Correspondence Between Staff and Applicant

# TSG FOUNDATION

# Center for Spiritual Development

The Planning & Development Services Division has completed the review of the above referenced development application submitted on 11-2-2018. The following **1<sup>st</sup> Review Comments** represent the review performed by our team, and is intended to provide you with guidance for compliance with city codes, policies, and guidelines related to this application.

AS102

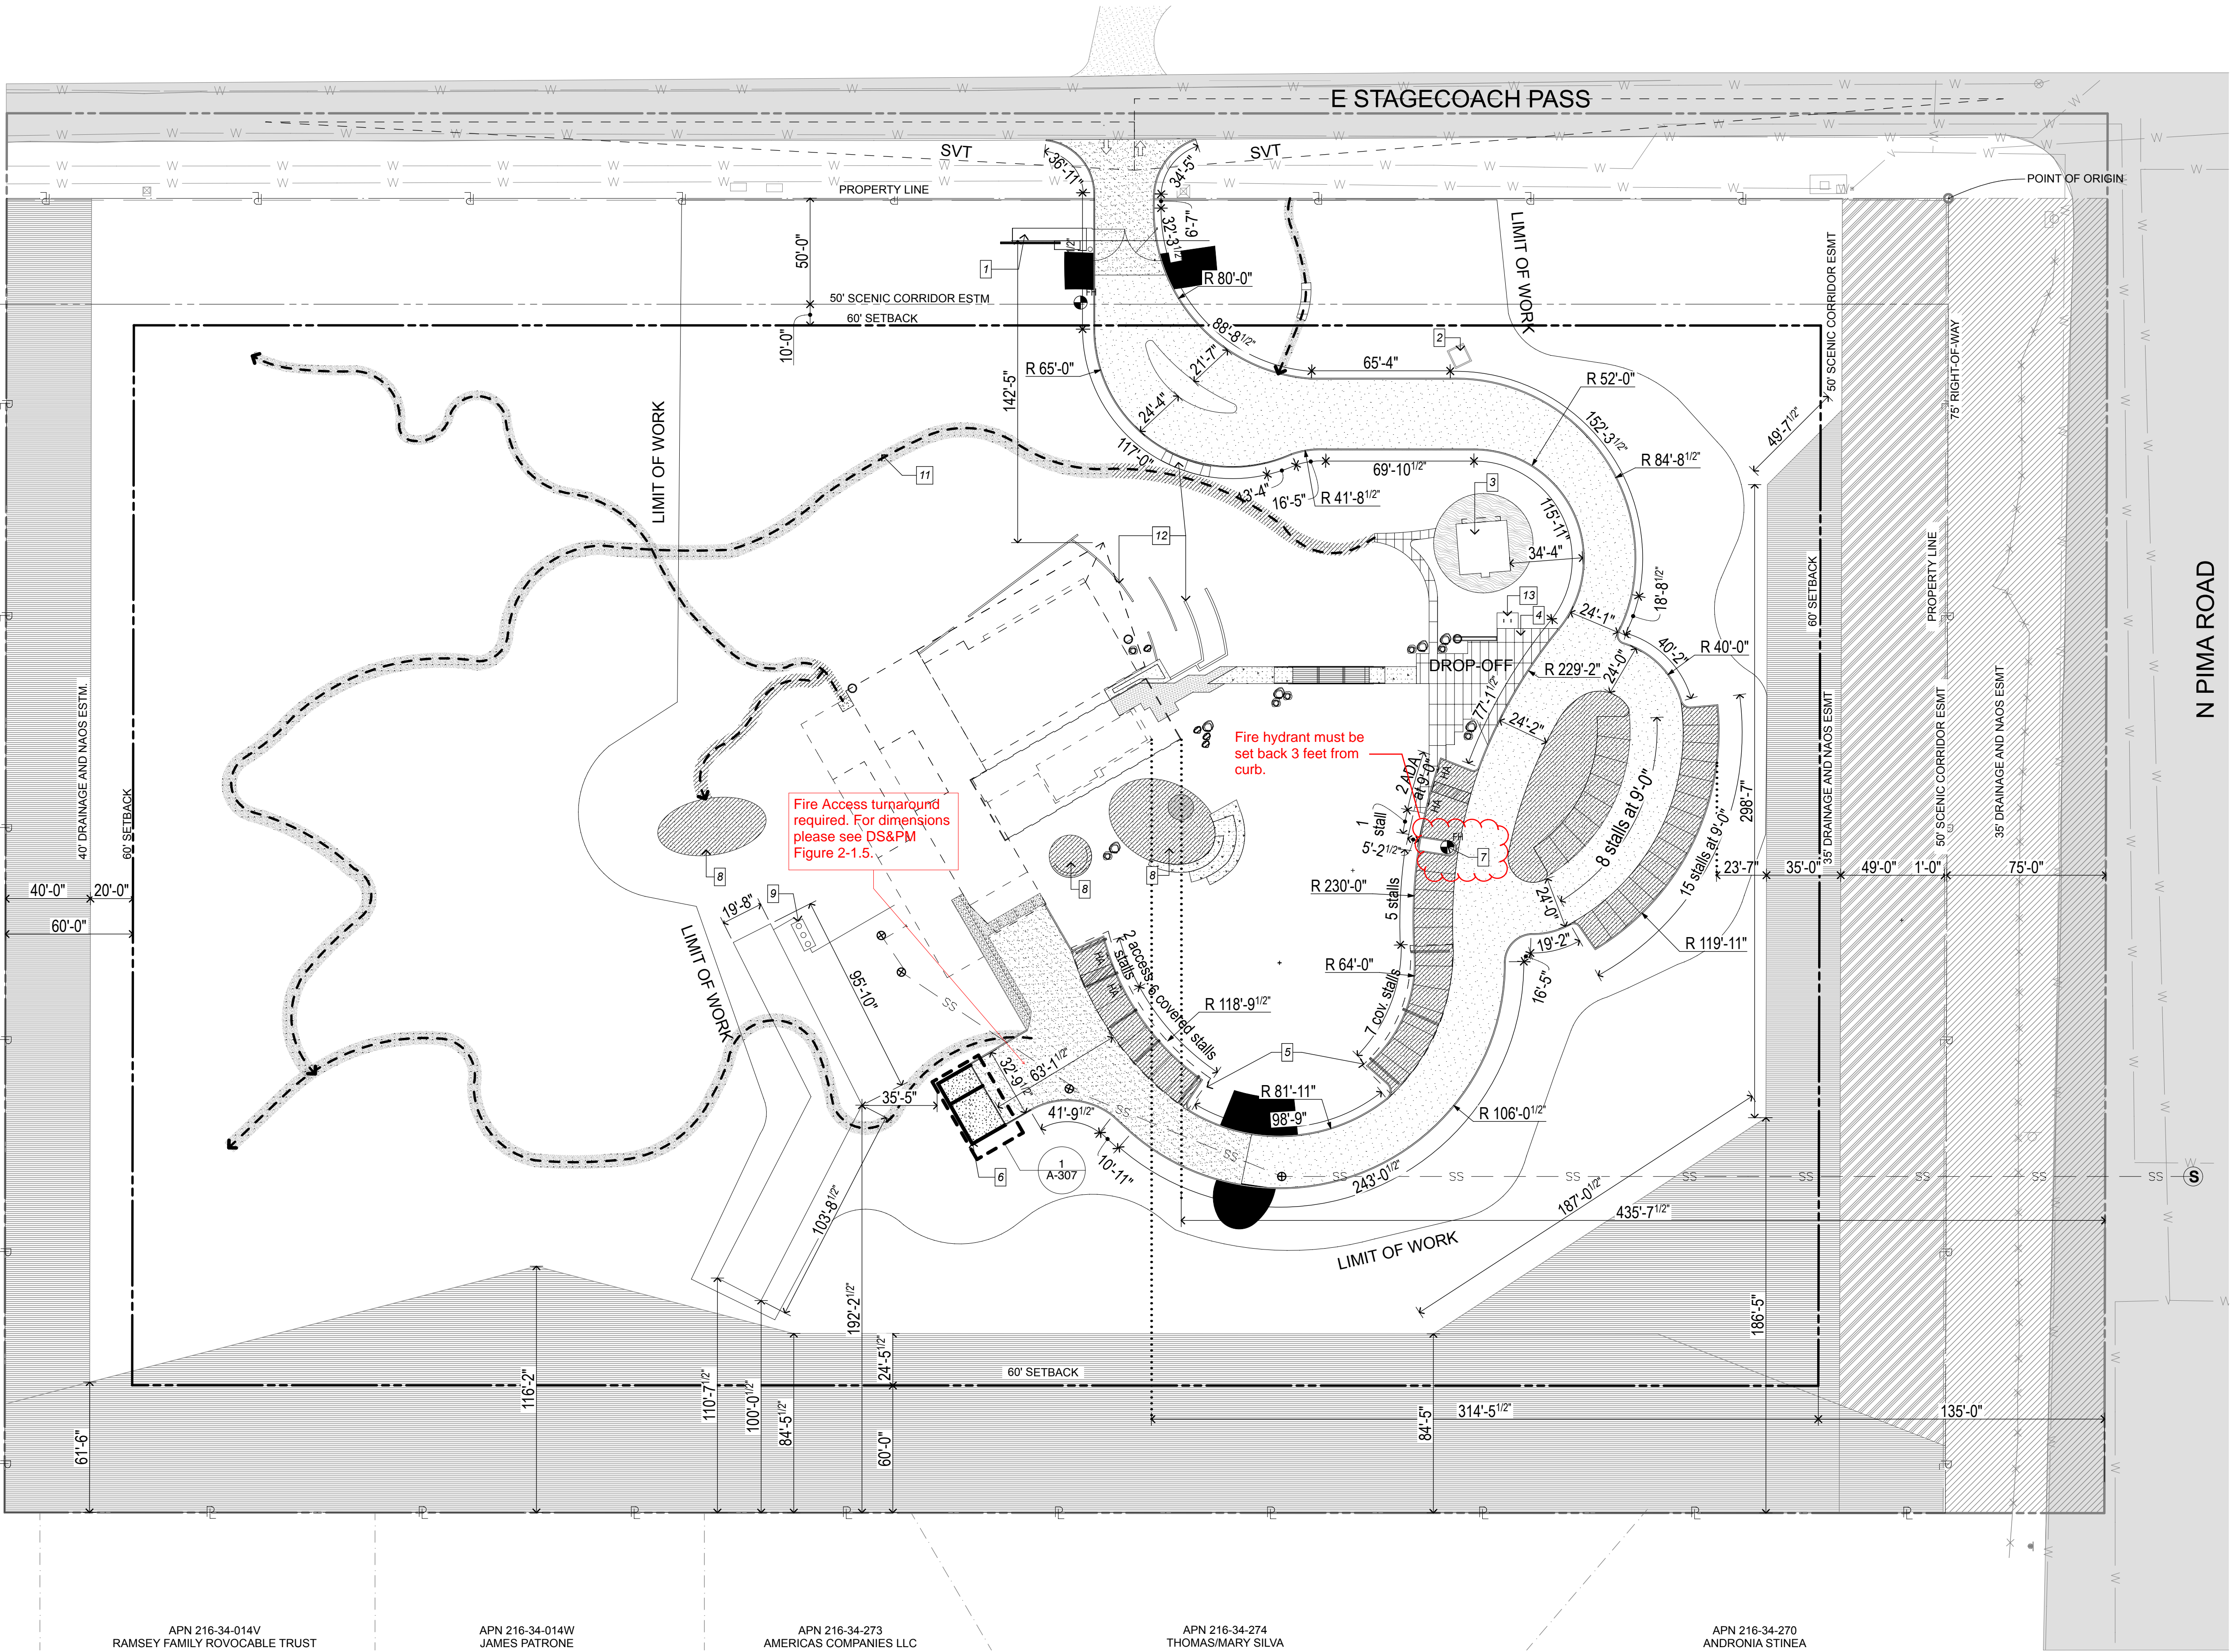
31. \*Revise the site plan so that it illustrates the necessary emergency access and fire lanes in compliance with the Scottsdale Design Standards & Policies Manual Section 2-1.802.

- a. Provide a written or bar scale on the site plan.
  - b. Provide a vicinity map on the site plan.
  - c. Revise the site plan to indicate the zoning district of all adjacent and abutting parcels.

- f. Revise the site plan to indicate the number of consecutive vehicle parking spaces in each row.
  - g. Revise the site plan to indicate the location and dimensions of all abutting rights-of-way, including alleys.

- j. Revise the site plan to indicate the dimension from each building/structure to the adjacent/abutting property line.
  - k. Revise the site plan to indicate the location of sidewalks, with pavement types, and dimensions.

- l. Revise the site plan to indicate the dimensions of the parking spaces, drive aisles, and landscape islands.

47. Please update the project narrative, and associated case materials, to identify the dedication of safety triangle easements at the site driveway (DSPM Section 5-3.123; Figure 5-3.27). [Easements indicated on site plan.](#)
